1370 STEWART ST

PRIORITIES & BOARD RECOMMENDATIONS

After visiting the site, considering the analysis of the site and context provided by the proponents, and hearing public comment, the Design Review Board members provided the following siting and design guidance.

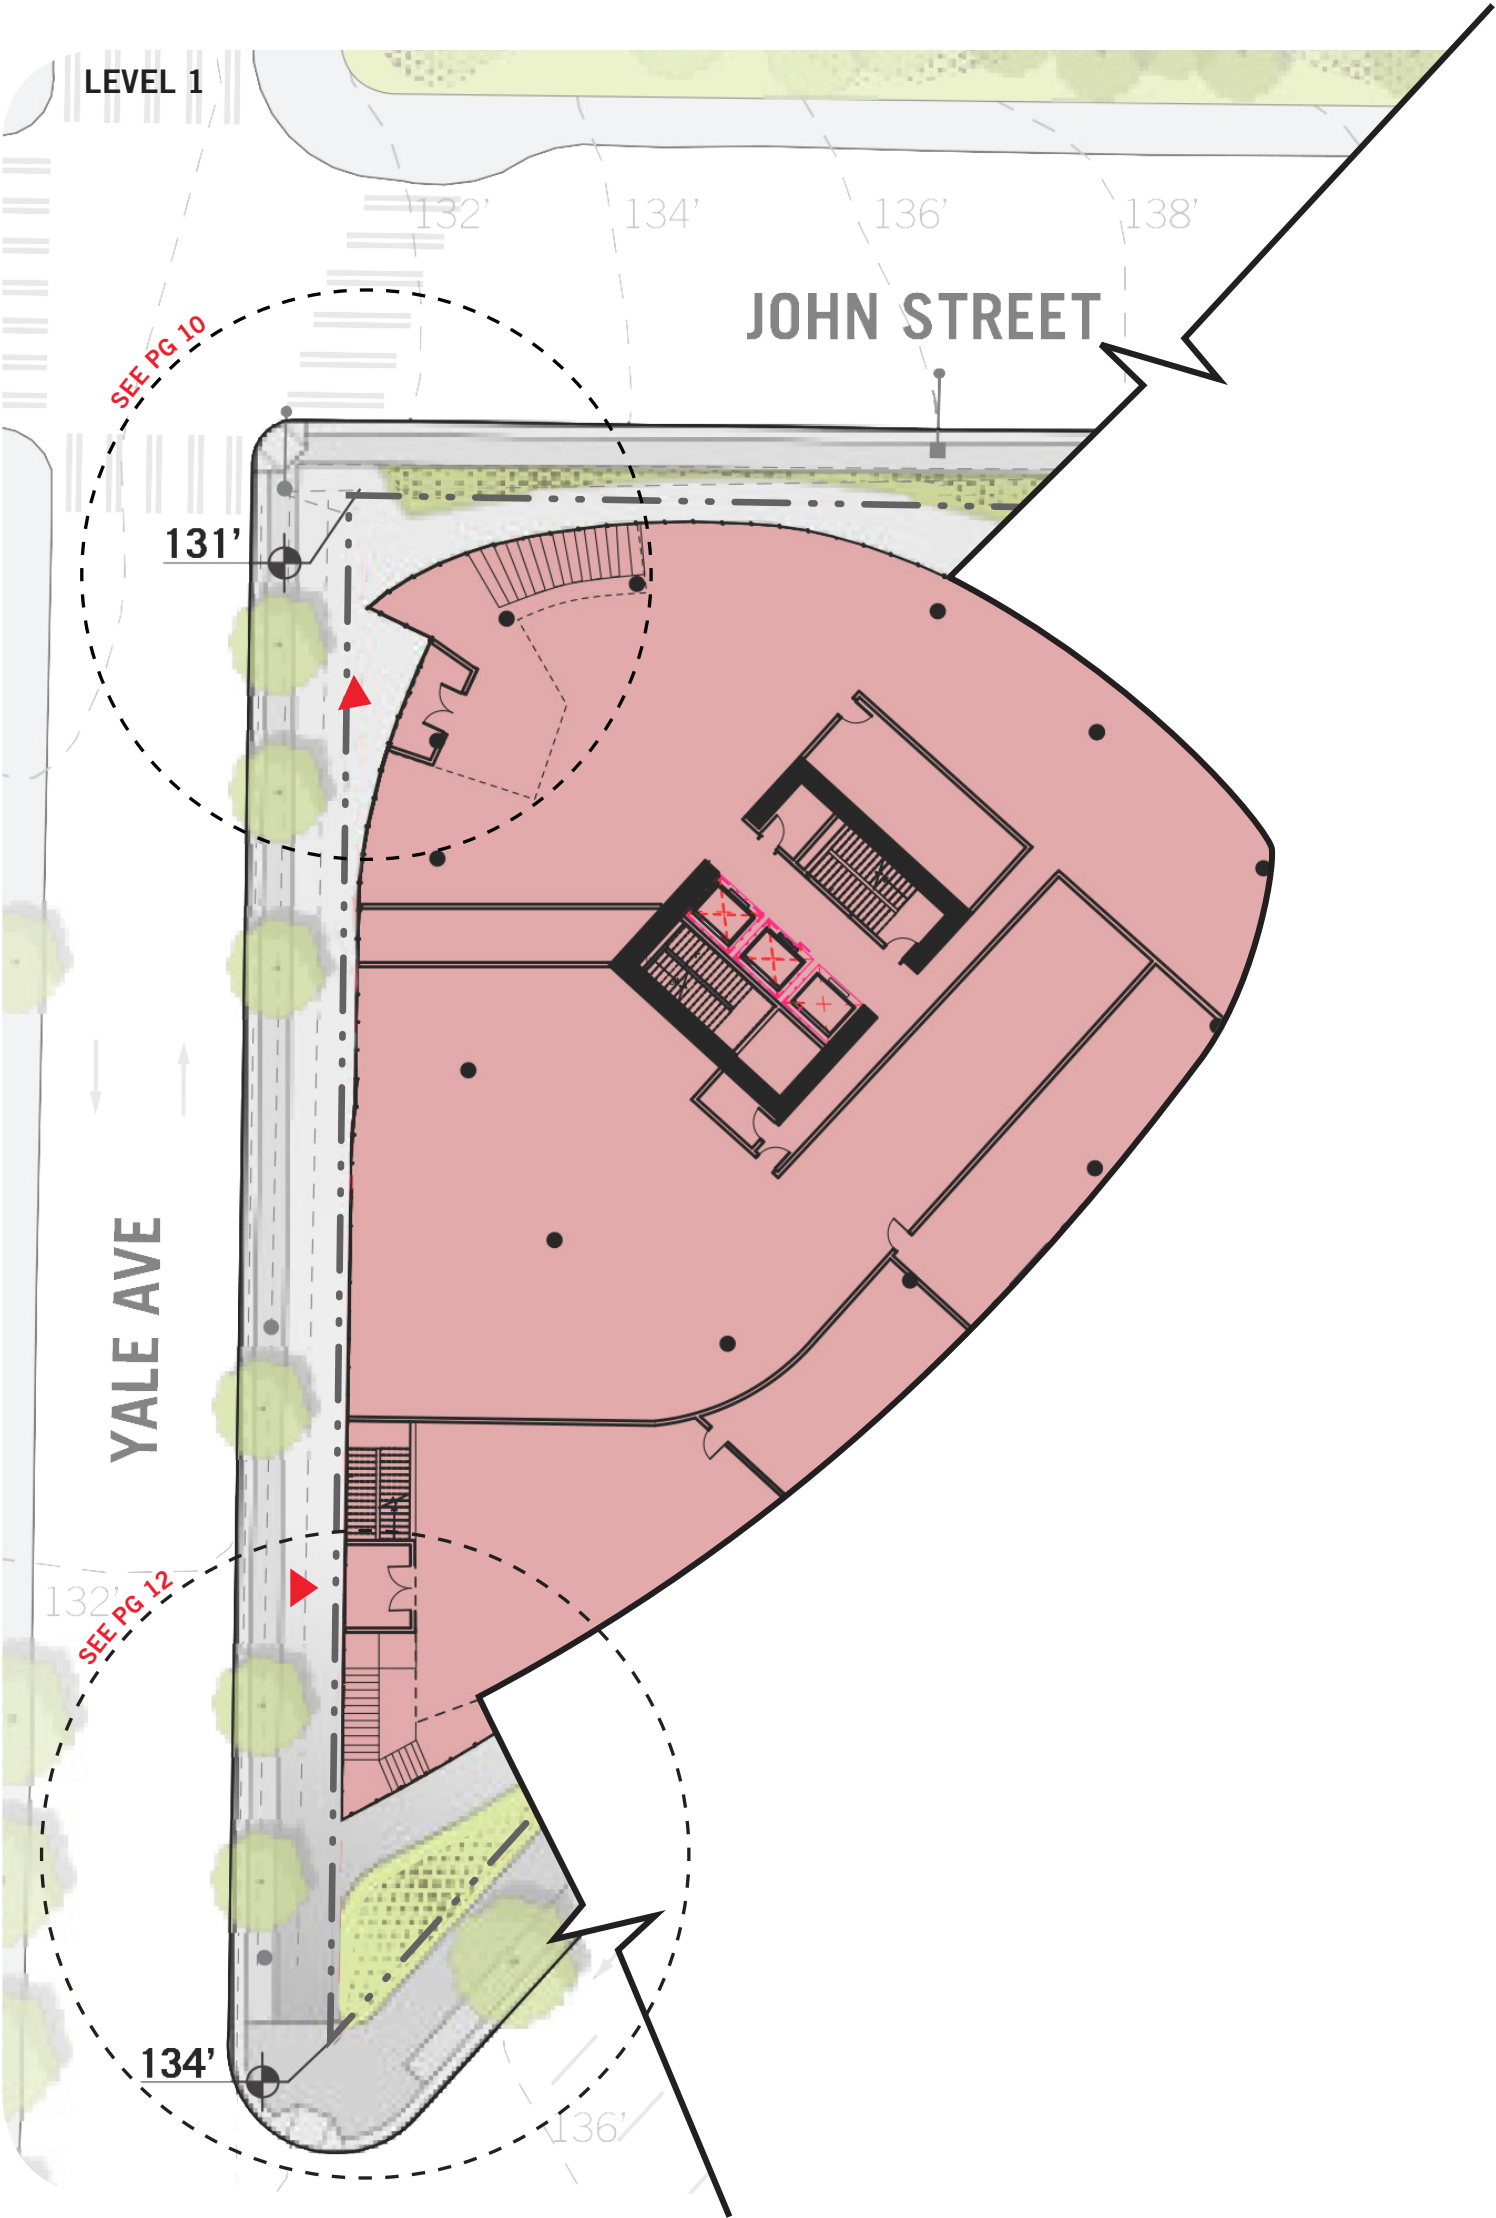
4A. The Board pointed out what appeared to be a concentration of ‘support’ areas at the north west corner and asked that these programming choices be revisited or explained in light of the corner’s importance in the pedestrian realm. (DC2-4-g)

5A. The Board supported the gesture at the northeast corner to the existing REI landscape but questioned apportioning the limited open space available to the least active corner. (DC3)

- i. The Board agreed that the current site plan could work but asked the applicant to explore the possibility moving that open space from the northeast to the northwest corner.

A forest buffer is proposed on the NE corner of the site and extends the landscape typology from REI across John Street, strengthening the evergreen gateway concept as an approach from I-5 and Capitol Hill. The proposed tower emerges from the evergreen foreground.

Active frontages and seating pockets along Yale Ave create a people oriented street. Curb bulbs at each corner with building setbacks increase opportunities for larger public gathering spaces, retail seating and plantings.

The existing American Sweetgum street tree language is reinforced with additional trees and a wide and continuous planting strip to buffer pedestrians from the busy arterial street. Planting is used along the building’s edge to soften the transition between the sidewalk and the building.

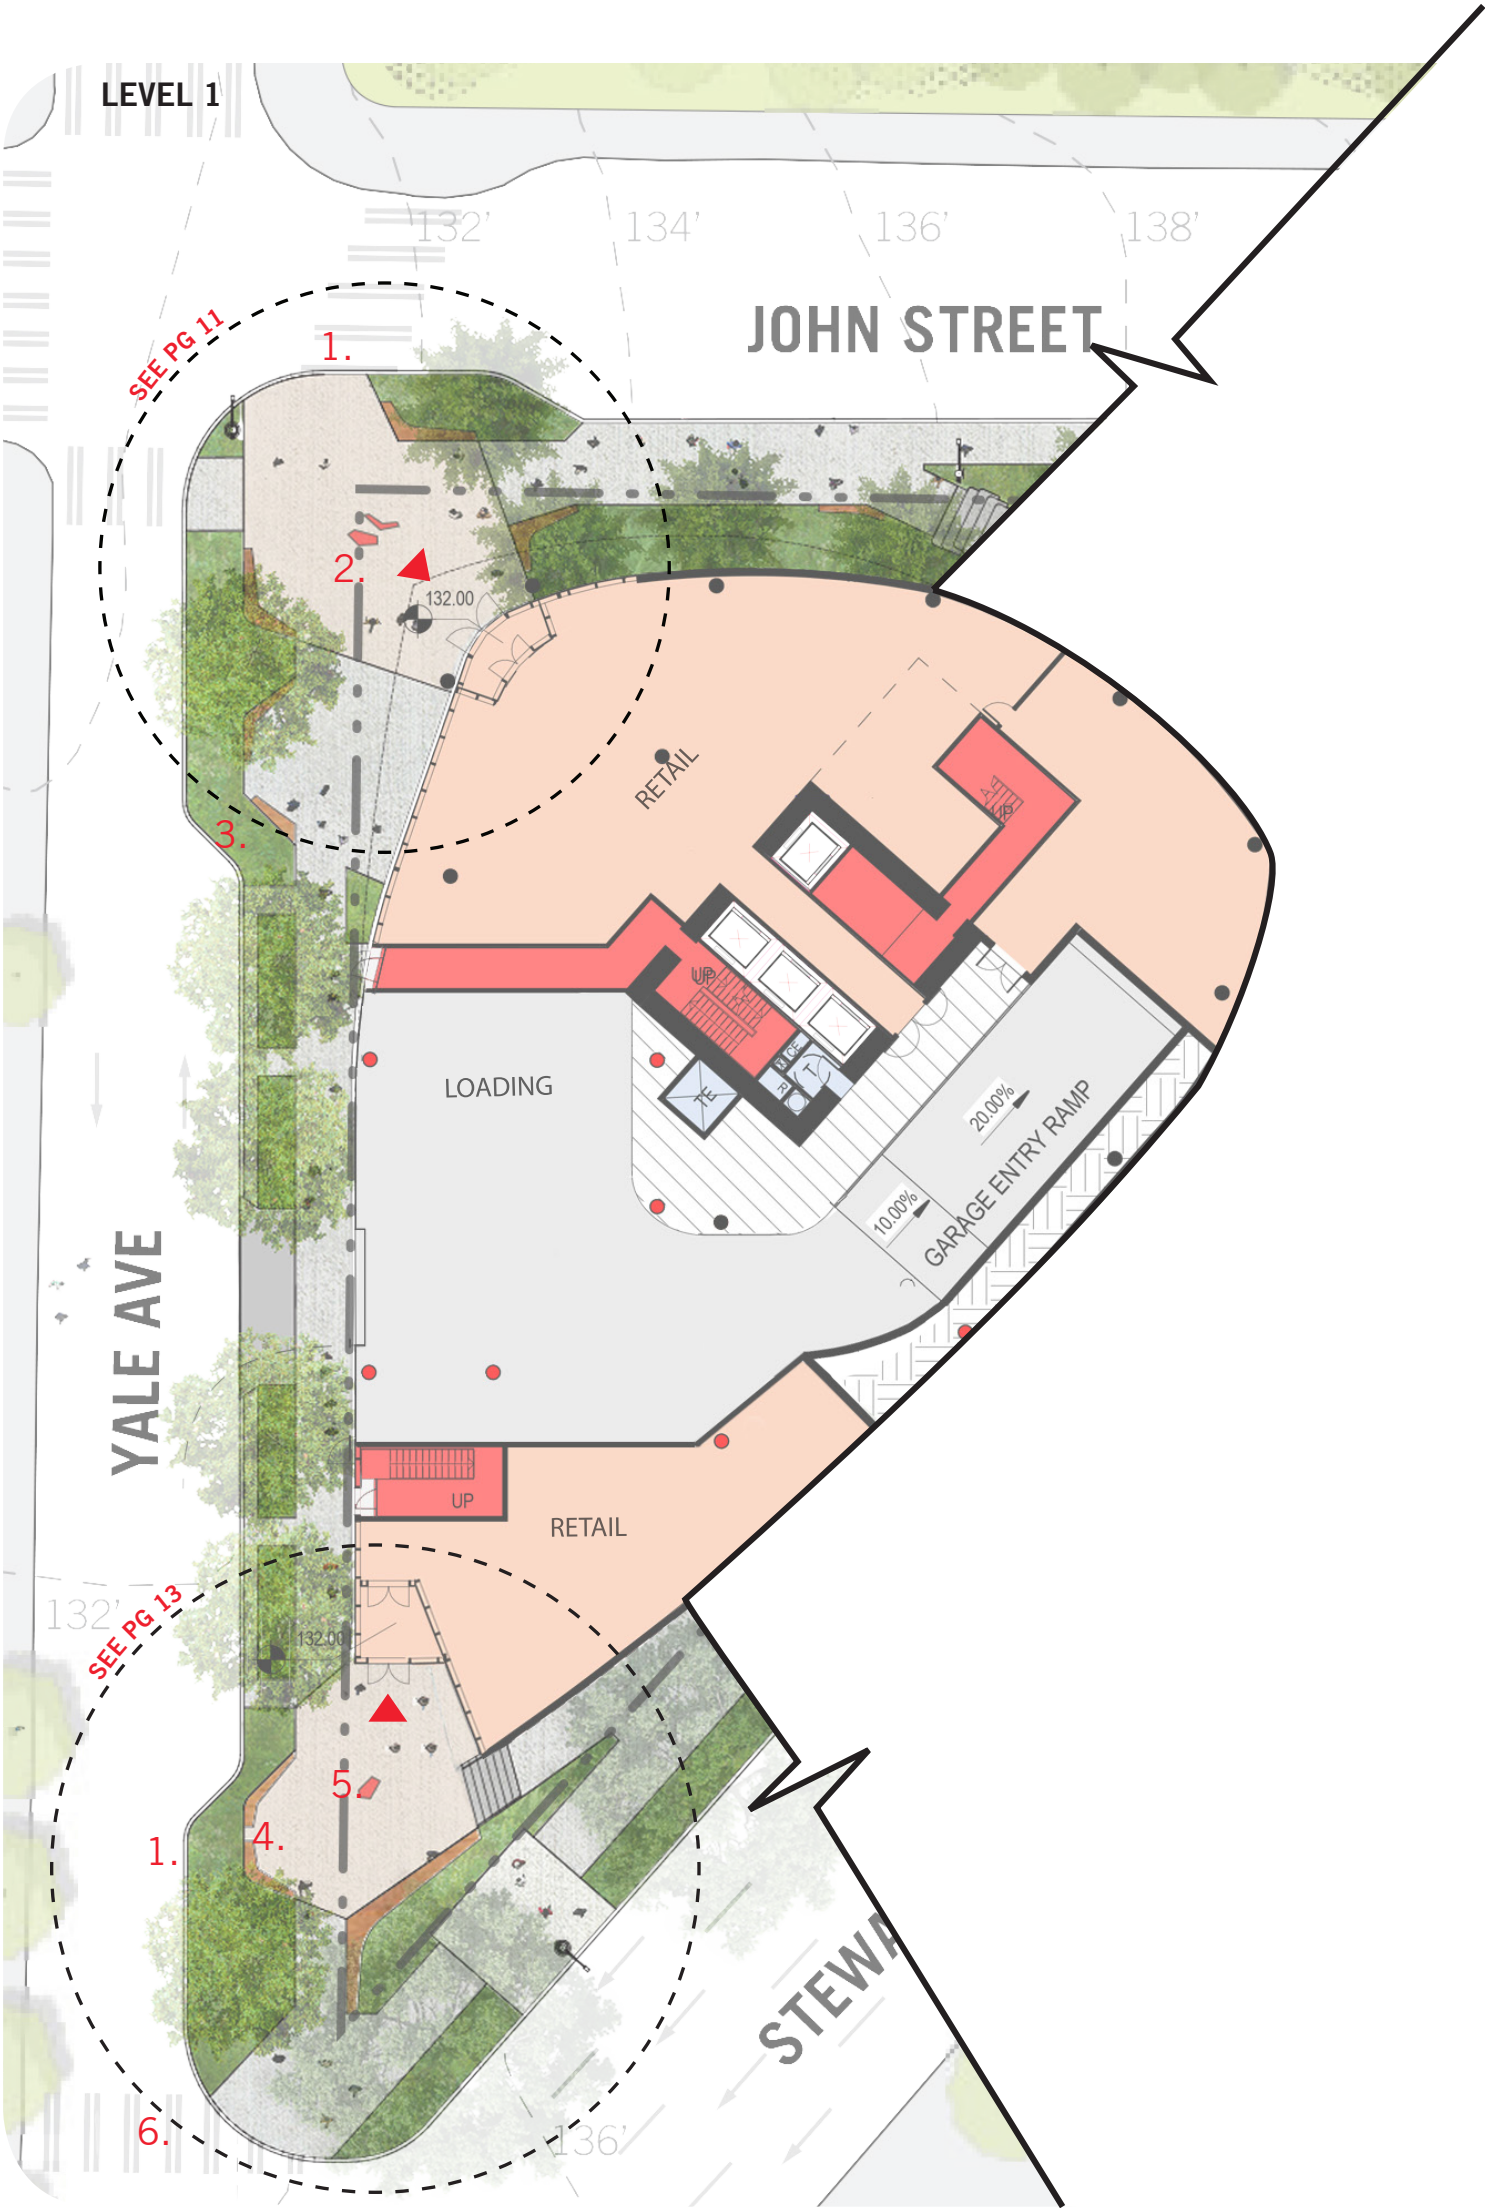
4A. The Board pointed out what appeared to be a concentration of ‘support’ areas at the north west corner and asked that these programming choices be revisited or explained in light of the corner’s importance in the pedestrian realm. (DC2-4-g)

5A. The Board supported the gesture at the northeast corner to the existing REI landscape but questioned apportioning the limited open space available to the least active corner. (DC3)

- i. The Board agreed that the current site plan could work but asked the applicant to explore the possibility moving that open space from the northeast to the northwest corner

The Yale Ave frontage is proposed as an extension of the streetscape found to the north and adjacent to the Alley 24 development. This section of Yale is characterized by active frontages (lobby and retail), seating, curbside parking and passenger loading and street tree plantings.

Additional setbacks and curb bulbs at each corner of Yale have been included in the revised plans. The additional area creates opportunities for public amenities including seating, additional landscape and potential feature elements such as water or art. The setback also allows for spill out of retail seating at the active frontage.

Pocket seating areas and street tree are also included between the corners to extend the streetscape language.
